STAFF REVIEW AND RECOMMENDATIONS PUBLIC HEARING JUNE 30, 2021

| ABBREVIATES PLAT: | DAIGON ALLEY | |
| REVIEWED BY: | AMY OTTO-BUCHANAN | CASE #: 2021-088 |

REQUEST: The request is to create two lots from Tax Parcel B10 to be known as **DAIGON ALLEY**, containing 5 acres +/-. The plat is located south of S. Bodenburg Loop and east of S. Bodenburg Spur, (Tax ID #117N02E34B010); within the E ½ NW ¼ NE ¼ NW ¼ Section 34, Township 17 North, Range 02 East, Seward Meridian, Alaska.

Agenda Copy JUN 0 -1 2021 SURVEYOR'S CERTIFICATE

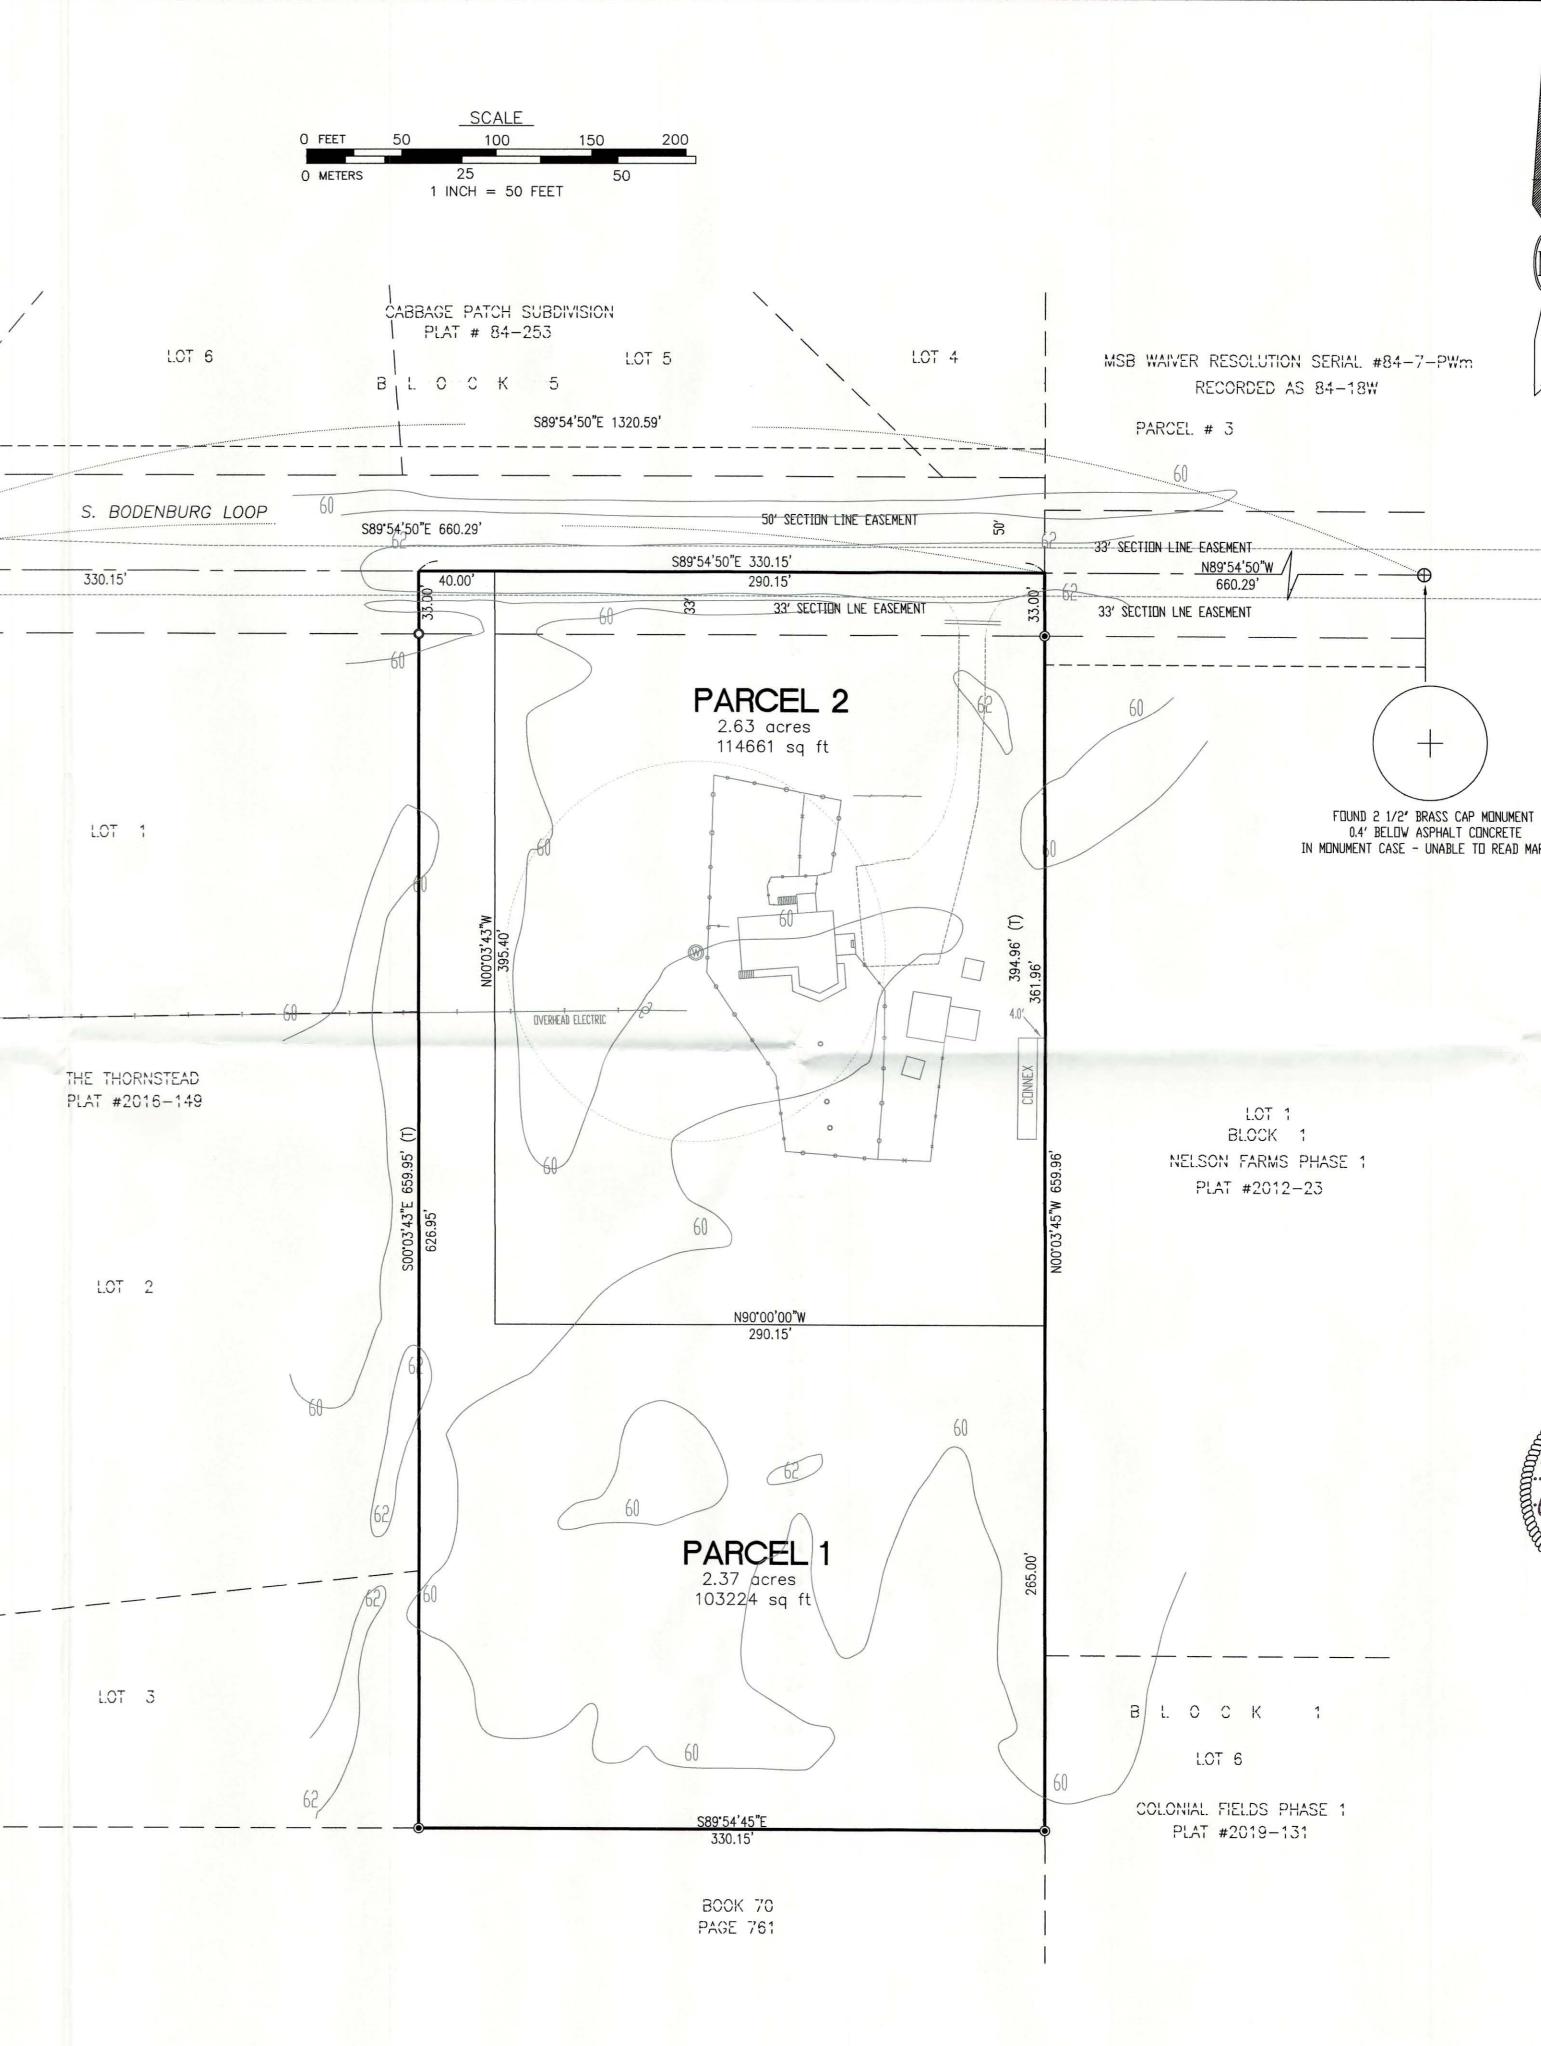
DISCUSSION: The proposed subdivision is located directly south of W. Bodenburg Loop and east of S. Bodenburg Spur. Proposed Parcel 2 is a flag lot; pole portion is 40' wide, as required by MSB 43.20.300(E). S. Bodenburg Loop is owned and maintained by ADOT&PF. The Connex that is 4' from the east lot line will need to be moved (see *Recommendation #5*).

[EXTERNAL EMAIL - CAUTION: Do not open unexpected attachments or links.] MEA comments to include the attached easement in the plat notes.

- Both lots must share access onto Bodenburg Loop.
- Spring Hill (Spring Hill Development & Sorensen)
 - As per our comments on 3/11/2021:
 - All lots must use internal access. No direct access will be granted to Palmer-Fishhook for individual lots.
 - We recommend the petitioner dedicate access for the lots to Olivewood Drive. This could provide secondary access to the lots in the future.
